Proposed Residential Development,
(Southern Site), Glenamuck,
Kilternan, Dublin 18

Stage 1 Quality Audit Report

Stage 1 Road Safety Audit

A.1.1 Delineation between Cycle Track and Footway at Development Access

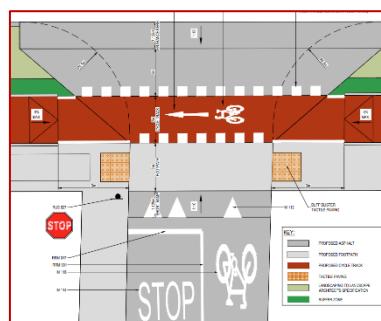
The cycle track on the Glenamuck District Distributor Road is indicated as being raised to the same level as the adjacent footway on the approach to, and through, the proposed raised-table crossing at the development vehicular access junction.

This could result in visually-impaired or partially-sighted pedestrians inadvertently straying into the cycle track, or enter the carriageway.

Similarly, the edge of the footpath on the development side of the crossing may be insufficiently delineated, possibly resulting in visually-impaired or partially-sighted pedestrians straying into the side road carriageway.

A level difference should be provided between the footway and cycle track on the approaches to, and through, the proposed raised-table crossing. This could be achieved, for example, by a 60mm high bevelled kerb which would facilitate vehicle crossover, whilst providing delineation for visually-impaired pedestrians. Similarly, delineation should be provided between the footway and the side road carriageway.

A.1.3 Crossing Points at Junction Corners

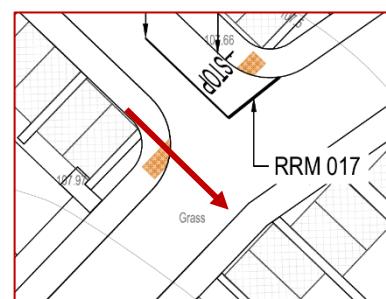
Some pedestrian crossing points have been indicated at the corners of internal junctions within the development.

This layout may lead to confusion for visually impaired pedestrians, as depending on the direction of their approach to the dropped kerb, they may misinterpret the direction of the crossing.

Separate pedestrian crossings of each carriageway, including dropped kerbs and tactile paving, should be provided at pedestrian crossing points along likely desire lines throughout the proposed development. Tactile paving with dropped kerbs should not be shared between two different crossing directions.

A.1.4 Footpath Terminates at Home Zone

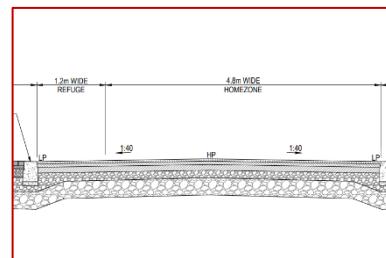
The footpath on the northern side of Street 2 is indicated terminating at a Home Zone at its eastern extent. No measures have been indicated at the transition to advise visually impaired pedestrians that they are entering an area shared with other road users. In addition, it is not clear where the 1.2m wide refuge area (e.g. Safe Zone) for visually impaired or partially-sighted pedestrians will be located within the Home Zone.

The 1.2m refuge area has been indicated on the cross sections as being provided on one side of the Home Zone only, however footpaths terminate at the Home Zone on both sides in some locations.

The absence of measures to advise visually-impaired pedestrians when they are entering/leaving shared areas increases the difficulty for these road users in safely & independently navigating the proposed road layout.

A 'Safe Zone' should be provided within the Home Zones in accordance with the guidance published by the National Disability Authority and appropriate tactile paving should be provided at the transitions between segregated footpaths/carriageways and shared areas.

A.1.6 Depth of Tactile Paving

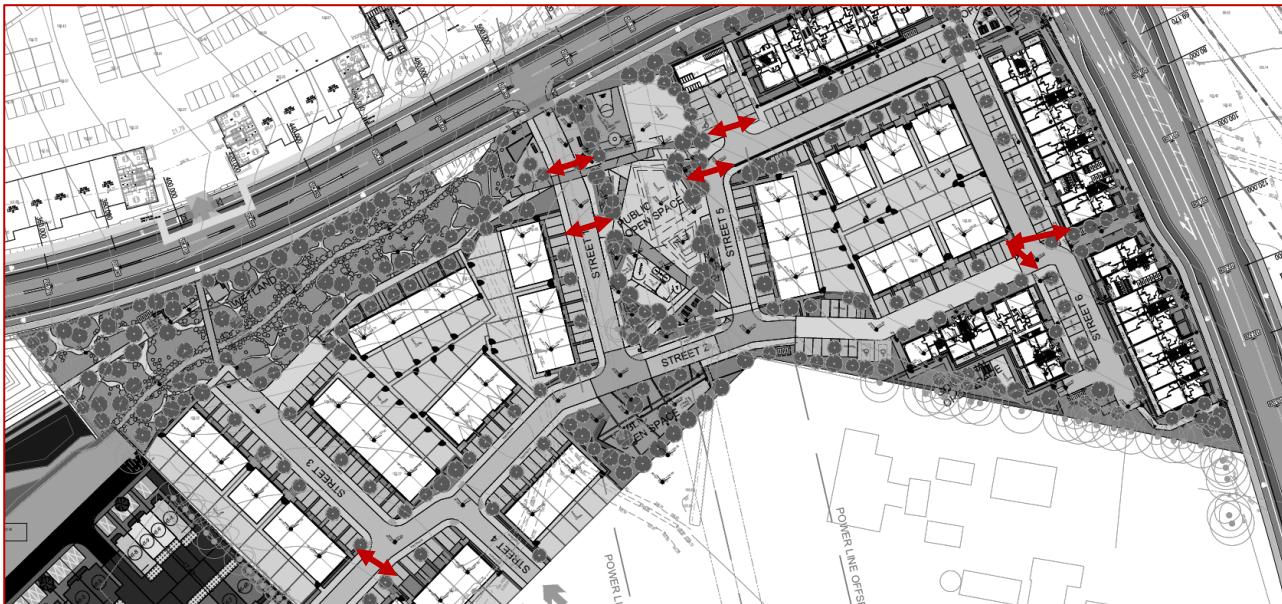
Dropped kerbs and associated tactile paving have been indicated at a proposed crossing of Street 5. There is an in-line approach to the northern crossing point, which could lead to visually-impaired pedestrian inadvertently stepping over the tactile paving and entering the carriageway.

The depth of tactile paving for in-line approaches to dropped kerbs should be 1.2m minimum.

A.1.8 Delineation between Raised Table and Footpath

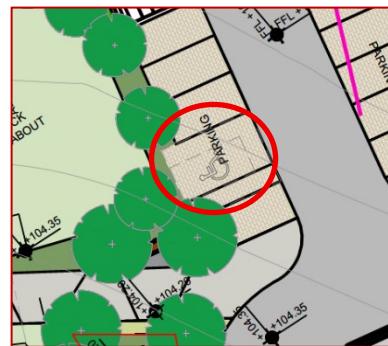
Raised tables have been indicated at a number of internal junctions within the proposed development. It is unclear, at this early stage in the design development, if a level difference would be provided between the top of the raised table and the adjacent footpath, away from where tactile paving has been indicated at pedestrian crossings, or if the footpath will be flush with the top of the raised table.

If adequate delineation is not provided between the top of the raised table and the adjacent footpath visually impaired pedestrians could inadvertently enter the carriageway.

A level difference, detectable by a visually impaired pedestrian, should be provided between the footpath and top of the raised table away from proposed crossing locations.

A.1.10 Warning Tactile Paving at Steps

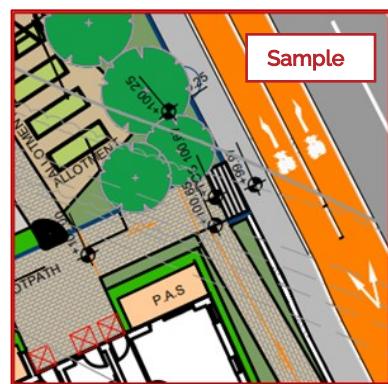
Steps have been indicated at a number of the pedestrian accesses to the development on the eastern side and the northern side of the proposed development.

Hazard warning tactile paving has not been indicated at the top and bottom of these steps. The absence of warning tactile paving at these locations may lead to visually impaired pedestrians being insufficiently advised of the hazard.

Hazard warning tactile paving should be provided at the top and bottom of steps within the development.

A.1.11 Ramped Access to the Development

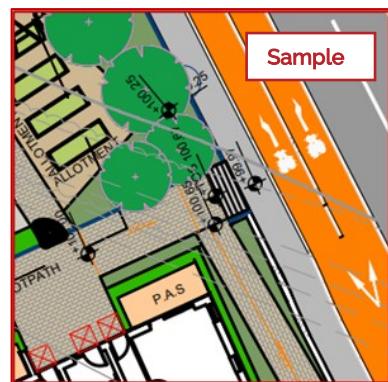
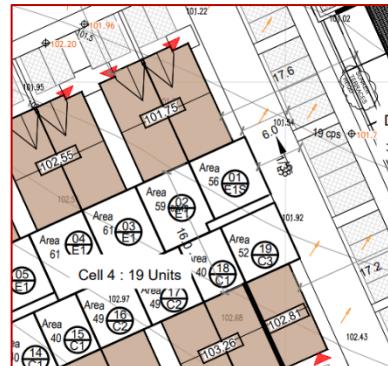
Steps have been indicated at a number of the pedestrian accesses to the development on the eastern side and the northern side of the proposed development. However, there is no ramped access indicated to facilitate the mobility-impaired, e.g. wheelchair users, to enter/exit the development at these locations.

This would increase the difficulty experienced by the mobility impaired, who may have to travel an unnecessarily lengthy distance when accessing/egress thing the development, for example via the main access on the Glenamuck District Distributor Road.

Ramps should be provided adjacent to, or instead of, the steps at the non-motorised road user accesses to the development and buildings, with appropriate gradients and landings.

B.1.2 Width of Route to Bike Store

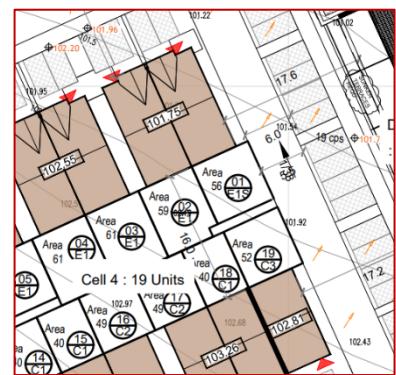
A bike store is indicated to the west of Duplex Block A, which would be accessed via a footpath. It is unclear if the width of the footpath is sufficiently wide enough to accommodate the expected peak volume of cyclists and pedestrians, leading to some pedestrians or cyclists travelling on the adjacent verge.

The route to/from the bike store should be wide enough to safely accommodate the expected peak volumes of pedestrians & cyclists.

C.1.5 Width of Route to Bike Store

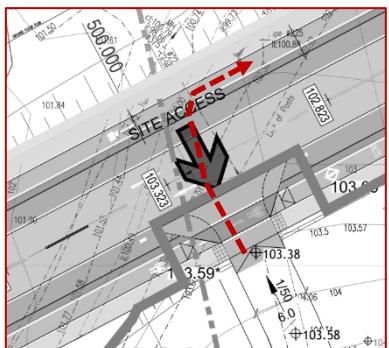
A bike store is indicated to the west of Duplex Block A, which would be accessed via a footpath. It is unclear if the width of the footpath is sufficiently wide enough to accommodate the expected peak volume of cyclists and pedestrians.

The route to/from the bike store should be wide enough to safely accommodate the expected peak volumes of pedestrians & cyclists.

C.1.7 NMU Link to Glenamuck Link Distributor Road

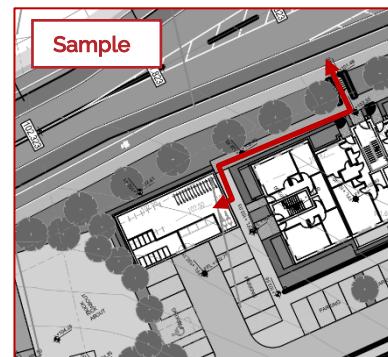
A footpath has been indicated in the southeast of the proposed development to/from the western side of the Glenamuck Link Distributor Road.

It is unclear if this footpath is intended to be used by both pedestrians and cyclists, however it is likely that both types of non-motorised road users would seek to use this route.

It is unclear if the width of the footpath is sufficiently wide enough to accommodate the expected peak volume of cyclists and pedestrians.

The link between the development and the Glenamuck Link Distributor Road should be wide enough to safely accommodate both cyclists and pedestrians.

3.1 Development Access Junction on GDDR

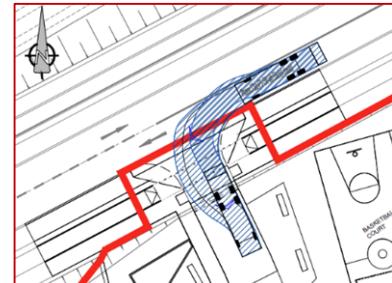
Summary: Large vehicles entering the development from the Glenamuck District Distributor Road may come to a halt within the Distributor Road when another vehicle is waiting to exit the development, possibly leading shunt collisions.

Large vehicles entering the development from the Glenamuck District Distributor Road may come to a halt on the Glenamuck District Distributor Road should a vehicle leaving the development be stopped at the stop line waiting to join the Distributor Road.

Following drivers on the Distributor Road may not anticipate a vehicle coming to a halt when entering the development junction, leading to late braking and rear-end shunt collisions.

The layout of the development access junction with the Glenamuck District Distributor Road should accommodate vehicles leaving the Distributor Road without having to halt for exiting development traffic.

3.2 Left-turning Driver's awareness of Cyclists at Development Access

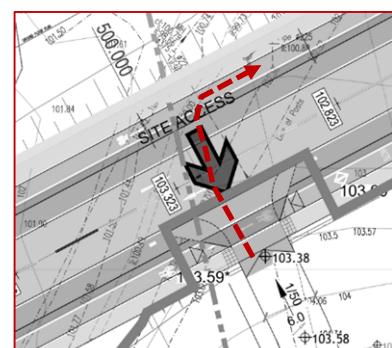
Summary: Left-turning drivers from the Glenamuck District Distributor Road may have insufficient visibility of an approaching cyclist due to the vehicle angle & partial setback arrangement.

The likely angle of approach of a left-turning vehicle to the partially set-back cycle track at the development access junction may not afford adequate visibility for left-turning drivers towards approaching cyclists, as the drivers would have to turn and look over their shoulder, and could result in unsafe cycle track crossings by vehicles leading to collisions with cyclists..

The cycle track crossing at the development access junction should be a fully set back, arrangement.

3.3 Right-turning Cyclists at Development Access

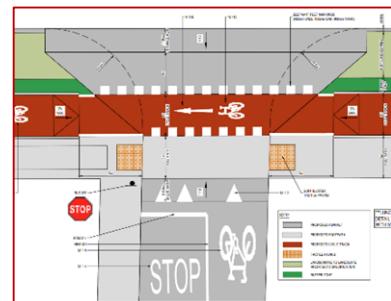
Summary: It is unclear how cyclists would travel safely to/from the cycle track on the northern side of the Glenamuck District Distributor Road and the proposed development.

There are one-way cycle tracks on either side of the Glenamuck District Distributor Road, separated from the carriageway by a grass verge. No arrangement has been indicated on the northern side of the GDDR carriageway to cater for cyclists travelling to/from the cycle track on this side of the GDDR and the development.

This could lead to cyclists choosing to travel in the incorrect direction within the cycle track on the eastern side of the GDDR, increasing the risk of collisions with cyclists travelling in the opposing direction, or to cyclists remaining within the carriageway, increasing the risk of being struck by a vehicle.

Provide measures for cyclists to safely access/leave the cycle track on the northern side of the road when accessing or leaving the proposed development access.

3.4 Delineation between Cycle Track and Footway at Development Access

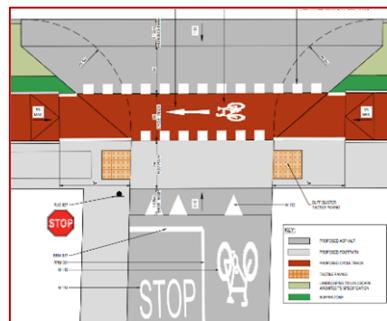
Summary: *The raised-table crossing includes both cycle track and footway at the same level, which may lead to visually-impaired pedestrians inadvertently straying into the cycle track, or carriageway, when crossing.*

The cycle track on the Glenamuck District Distributor Road is indicated as being raised to the same level as the adjacent footway on the approach to, and through, the proposed raised-table crossing at the development vehicular access junction.

This could result in visually-impaired or partially-sighted pedestrians inadvertently straying into the cycle track where they are at an increased risk of being struck by a cyclist, and from the cycle track they could inadvertently enter the carriageway where they are at an increased risk of being struck by a vehicle.

Similarly, the edge of the footpath on the development side of the crossing may be insufficiently delineated, possibly resulting in visually-impaired or partially-sighted pedestrians straying into the side road carriageway where they are at an increased risk of being struck by vehicle.

A level difference should be provided between the footway and cycle track on the approaches to, and through, the proposed raised-table crossing. This could be achieved, for example, by a 60mm high bevelled kerb which would facilitate vehicle crossover, whilst providing delineation for visually-impaired pedestrians. Similarly, delineation should be provided between the footway and the side road carriageway.

3.7 Delineator to Refuge

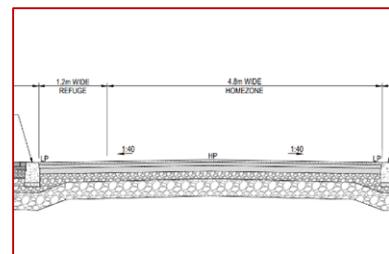
Summary: *It is unclear if a detectable delineator is to be provided to define the refuge area within Home Zone areas.*

A 1.2m wide refuge has been within the proposed Home Zone areas. It is unclear, however, if a detectable (e.g. tactile) delineator will be provided between the refuge area and the remainder of the Home Zone to assist the visually impaired.

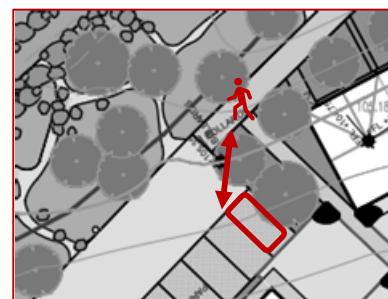
Summary: *Proposed planting, or parked vehicles, may impede inter-visibility at the transition between Home Zones & footpaths or at pedestrian crossings.*

Planting has been indicated throughout the development. In some locations the proposed planting adjacent to pedestrian crossings may impede inter-visibility between a pedestrian waiting at, or commencing, a crossing and an approaching driver, leading to unsafe crossings.

Proposed planting at the western end of the footpath along the southern side of the Wetland area may impede inter-visibility between a pedestrian leaving the footpath and entering the Home Zone and the driver of a vehicle reversing from the nearby parking spaces.

In addition, any number of pedestrian crossings have been indicated at locations adjacent to parking spaces. Parked vehicles may impede inter-visibility between pedestrians and approaching drivers, leading to unsafe crossings and a risk of vehicle/pedestrian collisions.

The proposed planting should not impede inter-visibility between road users within the development, in particular at pedestrian crossing locations.

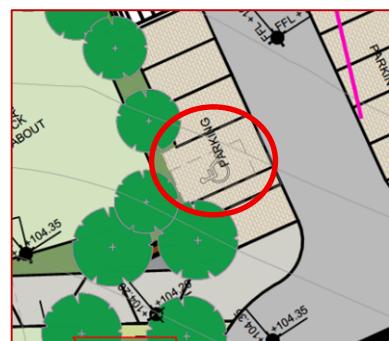
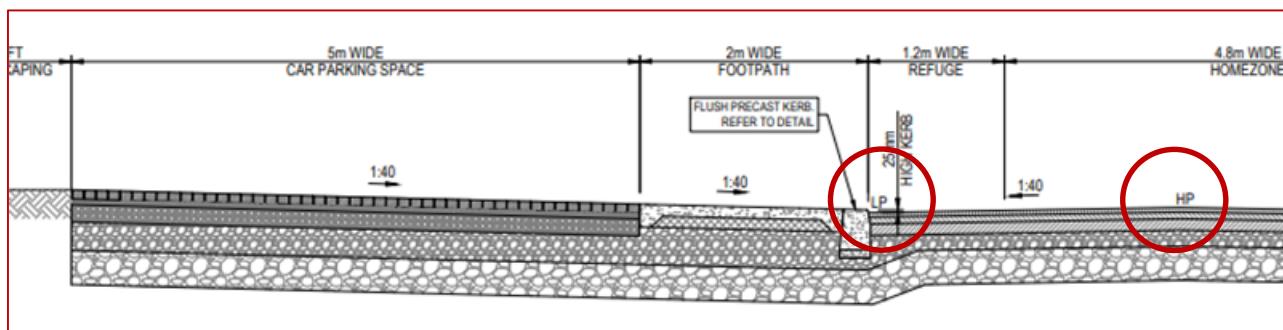
Summary: *It is unclear how it is intended that mobility-impaired vehicle occupants will travel to/from the nearest footpath and the proposed mobility-impaired parking space on the side road off Street 5.*

A mobility impaired parking space has been indicated on the side road off of Street 5, however there is no footpath indicated adjacent to the parking space, and the nearest dropped kerb is around the corner.

This layout would result in mobility impaired vehicle occupants having to travel within the carriageway to/from the dropped kerb location, where there is an increased risk of being struck by a vehicle.

Mobility-impaired parking spaces should be located adjacent to a footpath, with a dropped kerb and associated tactile paving to facilitate access to/from the parking space and the footpath for vehicle occupants.

3.15 Warning Tactile Paving at Steps

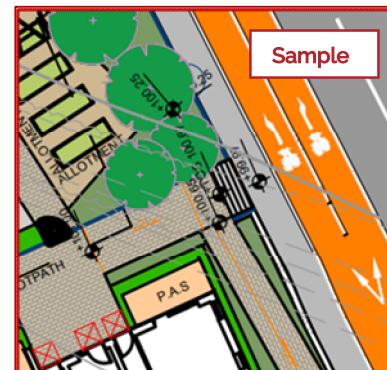
Summary: Hazard warning tactile paving has not been indicated at the top and bottom of the steps within the development.

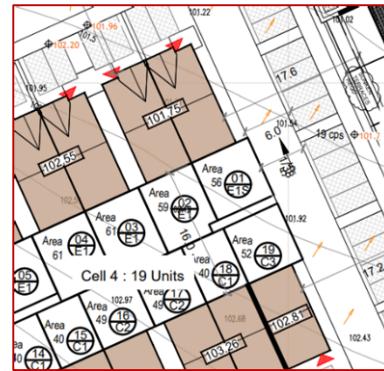
Summary: The side boundary walls to Units 56 and 52 extend to the Street 6 carriageway edge, increasing the risk of material damage collisions by vehicles with the boundary and may lead to pedestrians travelling within the adjacent carriageway.

The side boundary walls to Units 56 & 52 have an indicated as extending to the edge of the Street 6 carriageway. It is unclear from the information provided what type of boundary is proposed at this location, nevertheless the proximity of the boundary to the traffic carriageway increases the likelihood of material damage collisions between vehicles and the boundary.

In addition, the resulting discontinuity in the footpath on the western side of Street 6 could lead to pedestrians entering the adjacent carriageway, where they are at an increased risk of being struck by a vehicle.

Provide a continuous footpath at this location with an adequate lateral offset between the traffic carriageway and any boundary wall/fence.

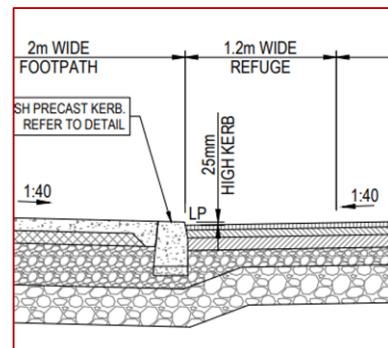
4.2 Trees have been indicated adjacent to the development access onto the Glenamuck District Distributor Road on Drawing NMP_Cowley Lands_Landscape Master Plan.

A note in Drawing 4426-MHT-XX-ZZ-DR-T-20-0011 (Rev.P01) and indicates that no trees will be provided in this area to facilitate the visibility splay for exiting drivers.

If trees are provided within the visibility splay this may impede visibility for exiting drivers resulting in unsafe exiting manoeuvres and possible vehicle/cyclist or side-on vehicle collisions.
